Form C-103

E. B. Anderson well No. 2
Unit "M" Section 6 T13S K38E
Lea County, New Mexico
West Bronco Devonian Field

**CONDITIONS OF APPROVAL
FOR PLUGGING AND ABANDONMENT
OCD - Southern District**

Operator:	BXP OPERATING, LLC	P.O. Box 7227	Dallas, TX75209	OGRID:	329487	Action Number:	16450	Action Type:	C-103F
OCD Reviewer	Condition								
kfortner	See attached conditions of approval Note changes on procedure

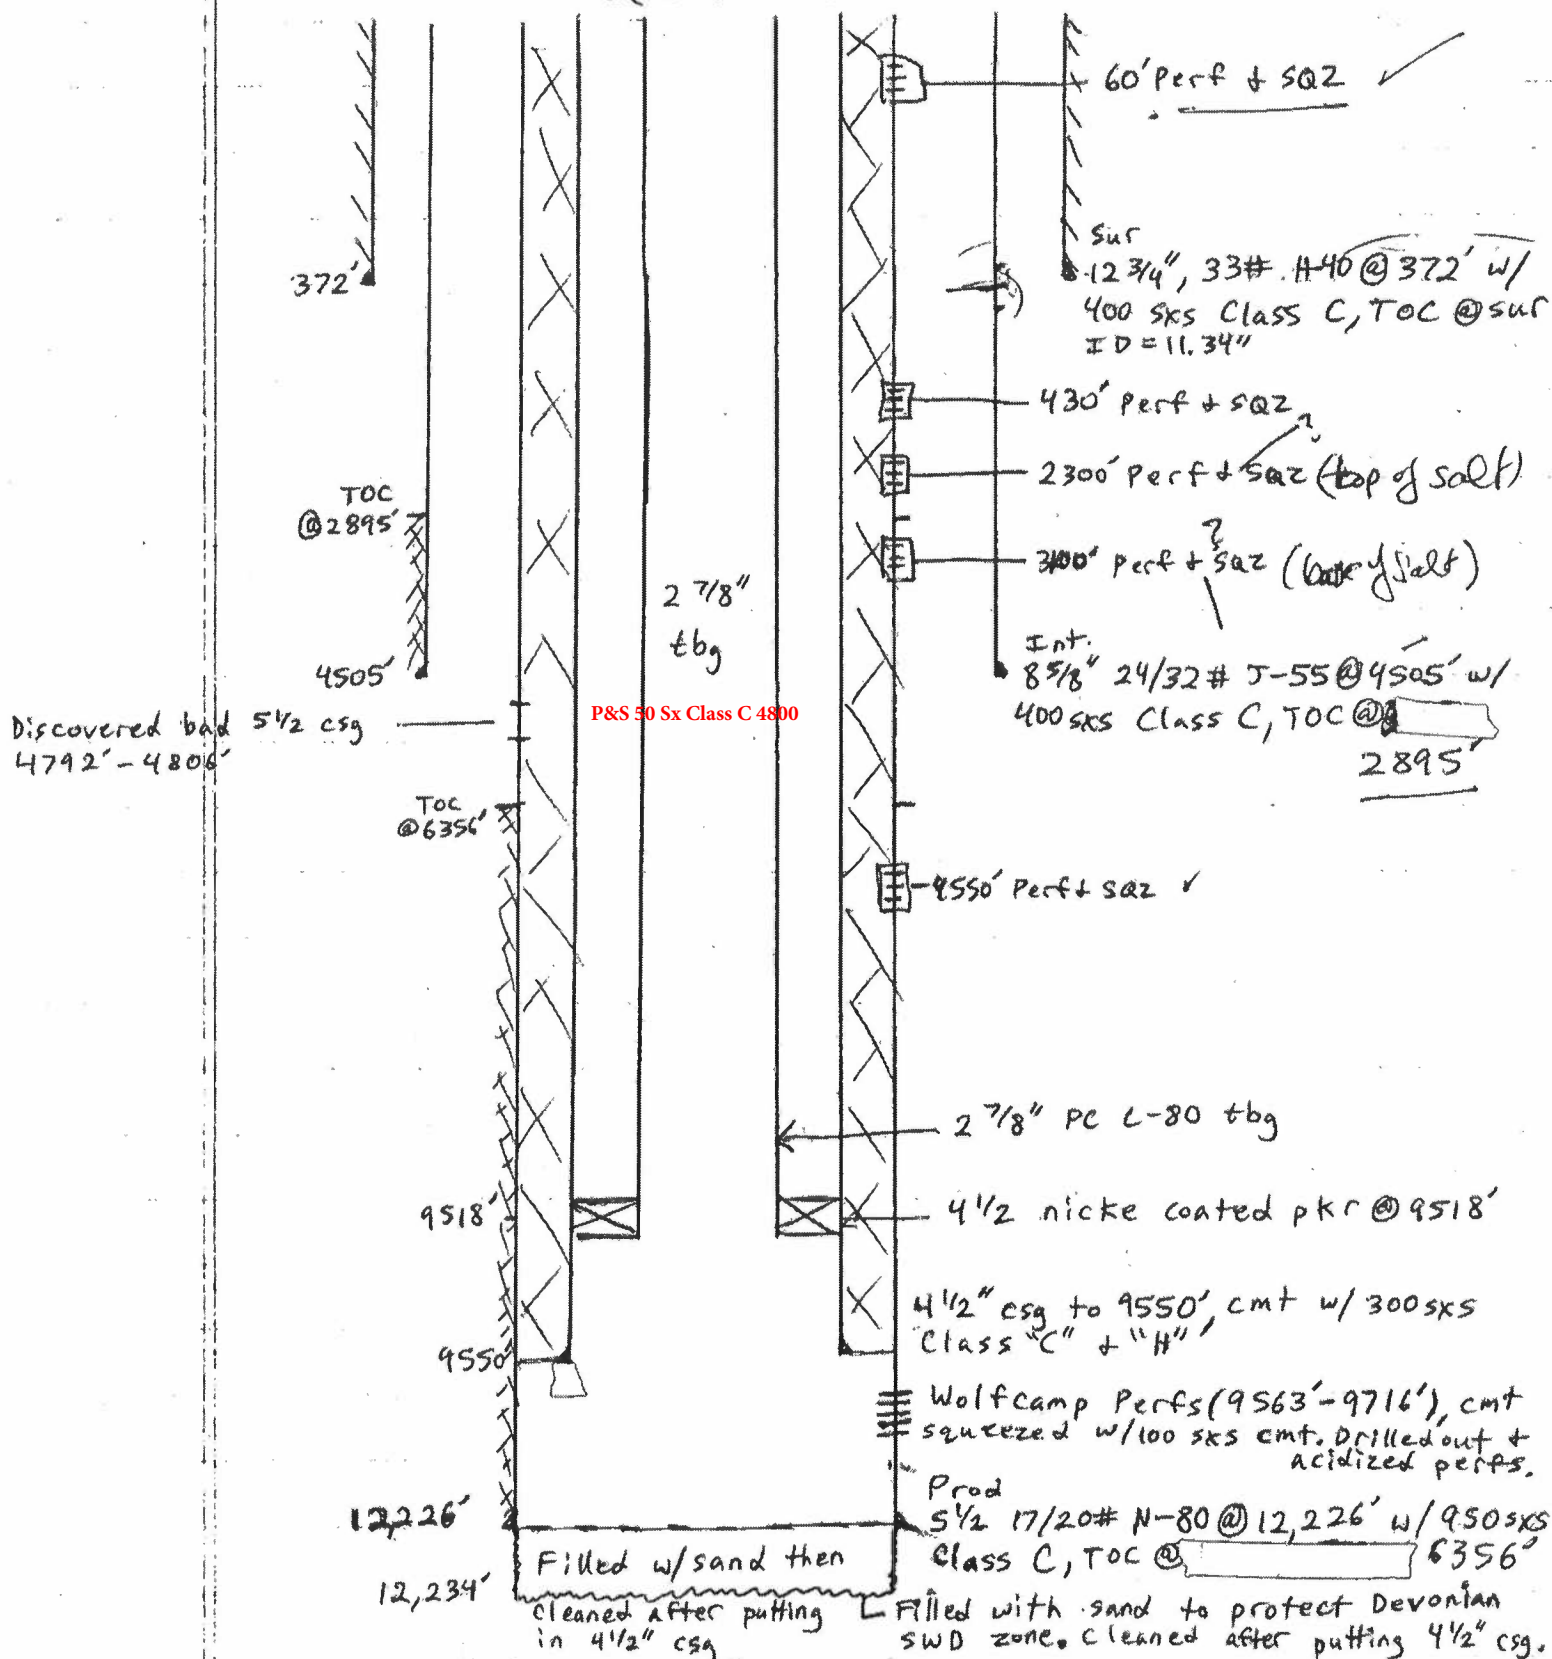
Test anchors. Run WSH. NU BOP Unseat PKY & TOH w/PC tubing (27/8")
Run gauge rns to 9500'. Run & Set CIBP @ 9500'. Dump 35' cement slurry on top. WOC 4 hrs.
TOH w/ 27/8" tubg. Circ. hole w/ 10" gelled brine. Spot 25 SXS. Cement @ 7000' 4 hrs. WOC. Tag.
~~C 4800~~ Pore 4 sh. holes @ ~~4500'~~. TOH cen PKY & tubg. Pump 50 SXS. Cement @ 50-50' out.
PLI & 4 holes @ 3100'. Size 50 SXS. Cement.
" " " 2300' " " " " "
" " " 380' " " " " " Circ to surface. Picture.

Rd well SU. Cut off well head. Install DHM. Cut anchors. (above ground DHM)
Empty steel pits. waste to G.M.-west Tatum. Rehab within 90 days. Final.
